Cabinet Member for Housing, Regeneration and the Climate Emergency

Date: 18 March 2021

Subject: Dorset Road – Zebra Crossing

DORSET ROAD ZEBRA CROSSING – MERTON PARK

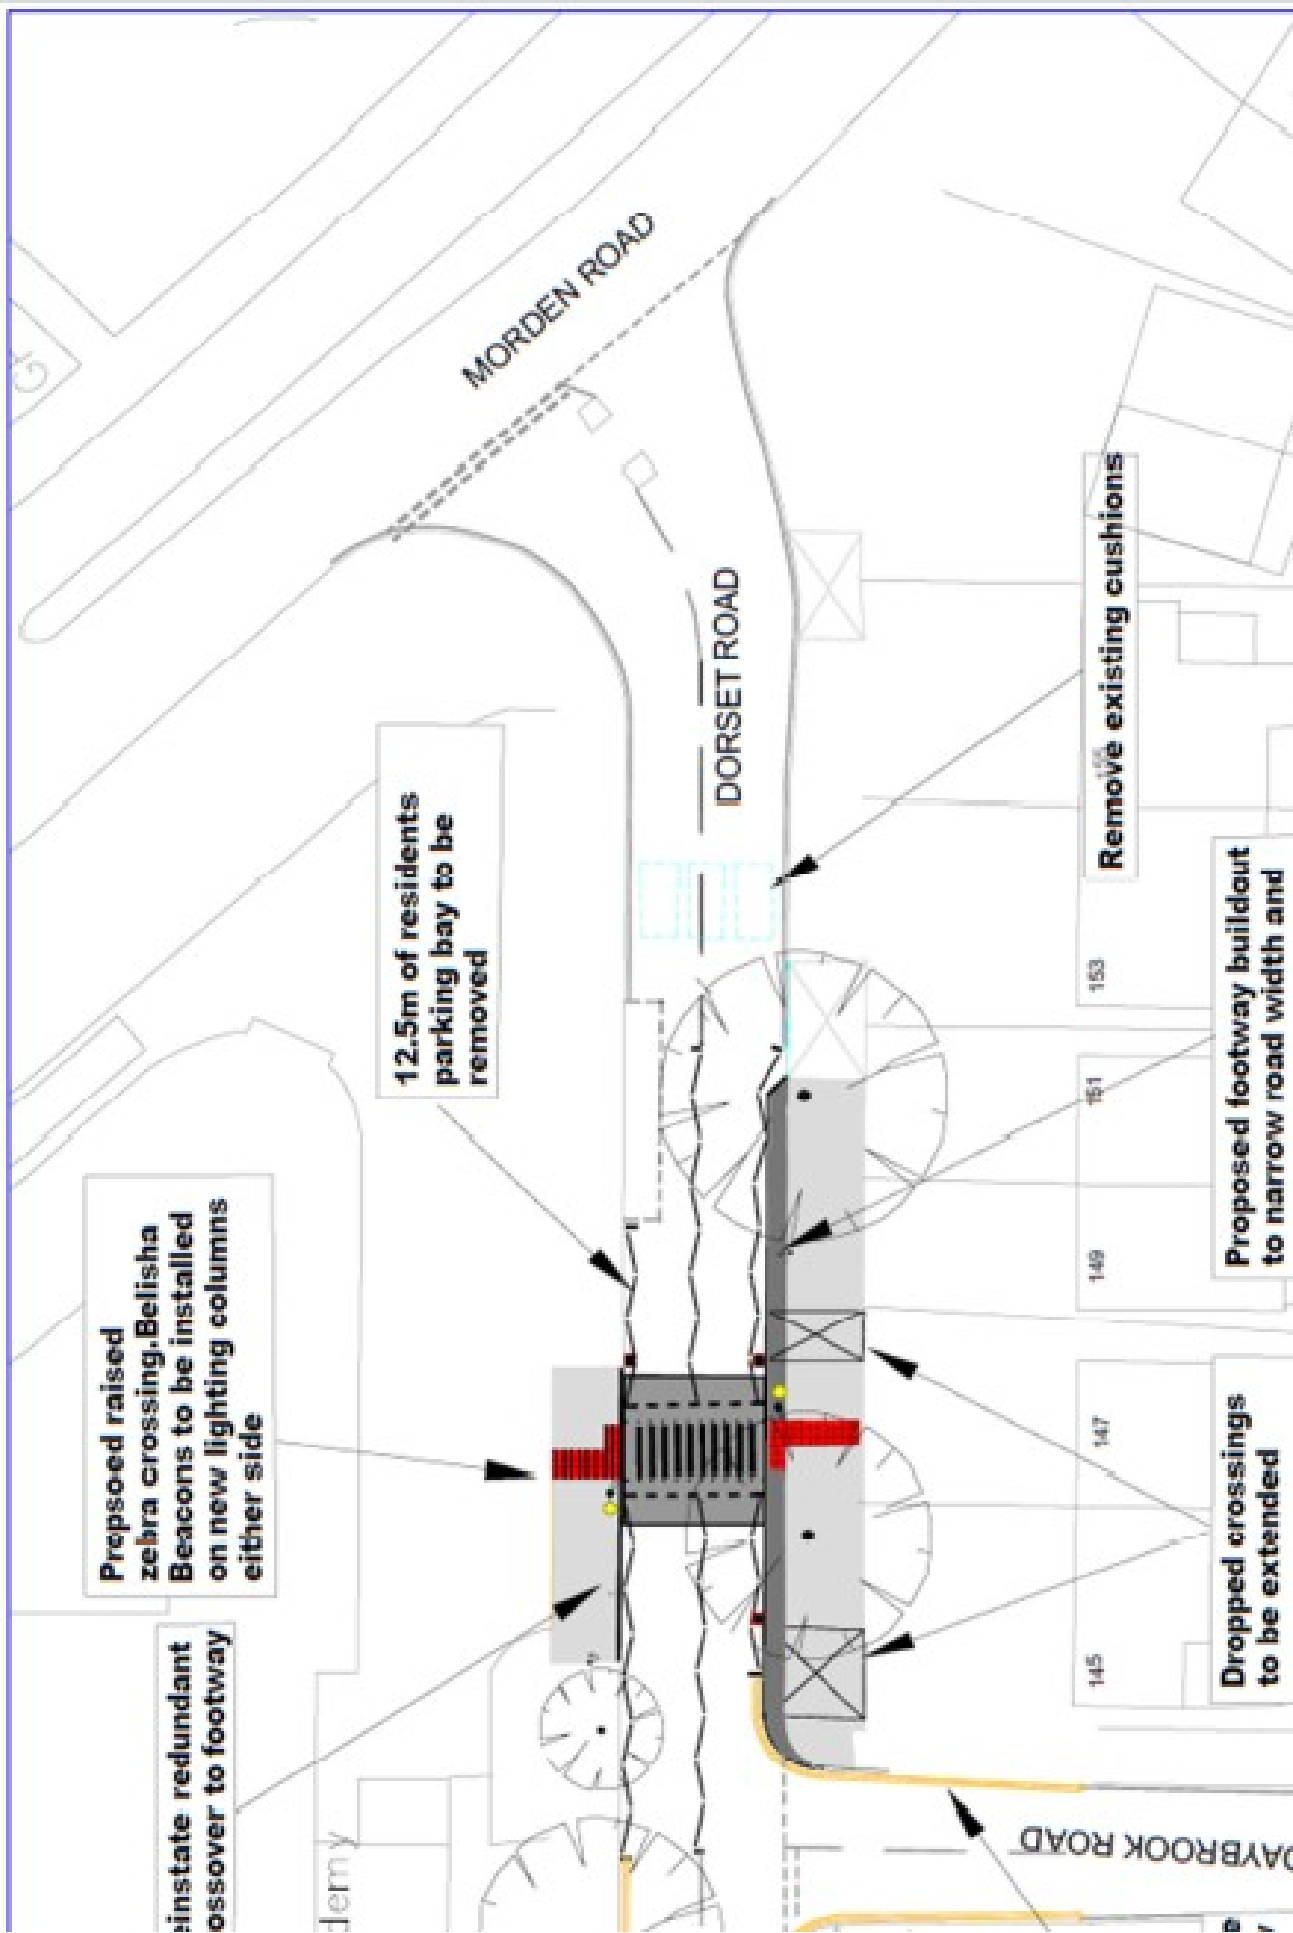
The narrowing of the road - I'm not sure I entirely understand how this will "improve visibility" and aid safety. Surely this would just create more traffic congestion - especially with drivers less confident with their vehicle's width - and in turn beget recklessness. Although if this is coupled with the removal of the parking bays, admittedly, that would work. Dare I say it, just the removal of the bays could be enough. No more having to peek out between parked vehicles is a welcome change.

The Belisha beacons - I know this is what makes a zebra crossing a zebra crossing but I'm deeply troubled by this. At least with the lack of clarity surrounding them. Regardless of how close we are to the main road, Dorset Road is still residential: and now we're getting lights, and crossings, and bollards and whatever else. I've always wanted grand pillars at the junction of Dorset Road and the main road (like at the junction of Lake Road and Woodside in Wimbledon Hill) to signify people are entering a residential area. But if we have to concede and get a crossing instead, I suppose we'll have to take that loss! ... but one with big flashing lights?

- Will these Belisha beacons be installed with courtesy shields - so it's visible from the road but protects houses from the light in the big orange ball?
- Will these only be active during school rush hour/start/end times? The idea of them will be a lot more palatable if this were the case.

If the beacons will be active 24 hours I find this to be completely absurd.
